Part No: D206-642-241

Part Name: Replacement Skidtube, High Gear with Standard Wearplates Fits LH or RH

DRAWING NO. D2650	TITLE 206/407 SKIDTUBE ASSEMBLIES	REV. F	DART AEROSPACE LTD ENGINEERING ORDER		D.E.O. NO. D2650-F-1	SHEET NO. SHEET 1 OF 1	SCALE NTS
DRAWN <i>[Signature]</i>	CHECKED A.P.	MFG. APPR. <i>[Signature]</i>	APPROVED <i>[Signature]</i>		DE APPR. <i>[Signature]</i>		
DATE 12.10.12	DATE 12.10.22	DATE 12.10.22	DATE 12.10.22		DATE 12.10.22

CHANGE C'BORED WELDED CROSSBOLT SPACERS TO SWAGED SPACERS

DETAIL B

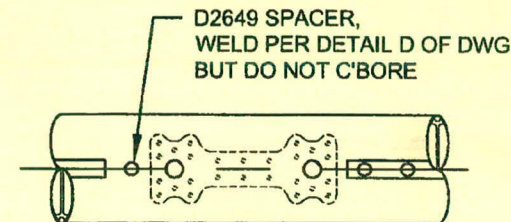
ADD DETAIL G BELOW, WHICH IS THE SAME SECTION VIEW AS DETAIL D OF DWG.

C'BORED HOLES ARE **NOW SWAGED** PER DETAIL G BELOW. FOR THE Ø0.375 HOLE THAT IS NOT C'BORED, WELD PER DETAIL D OF DWG (SEE AMENDED DETAIL B FOR REFERENCE).

DETAIL G

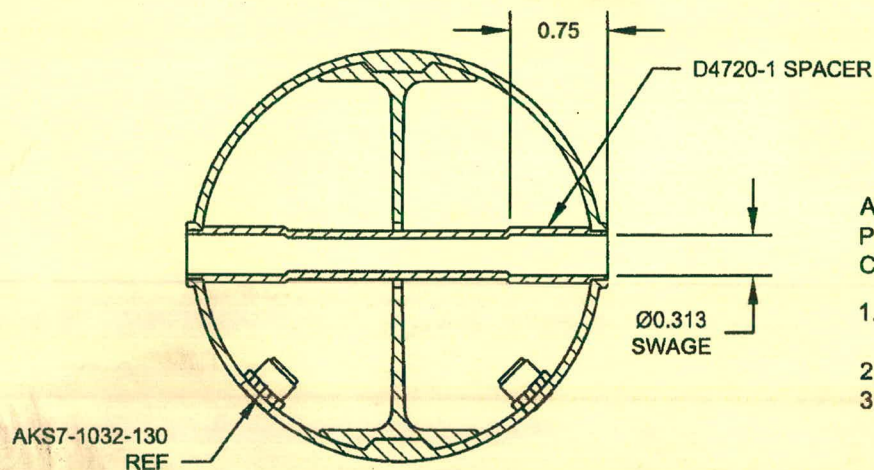
FOR Ø0.375 HOLES ONLY
FOR HOLES THAT ARE CURRENTLY C'BORED ONLY
NOT TO SCALE

AFTER DRILLING AND BENDING ASSEMBLY
PERFORM THE FOLLOWING FOR Ø0.375 HOLES THAT ARE
CURRENTLY C'BORED:

1. INSERT D4720-1 SPACER, 16 PL (-1) OR 17 PL (-3)
OR 19 PL (-5) OR 23 PL (-7)
2. SWAGE TO Ø0.313 X 0.75 DP PER QSI 002
3. TRIM / GRIND FLUSH PER QSI 002
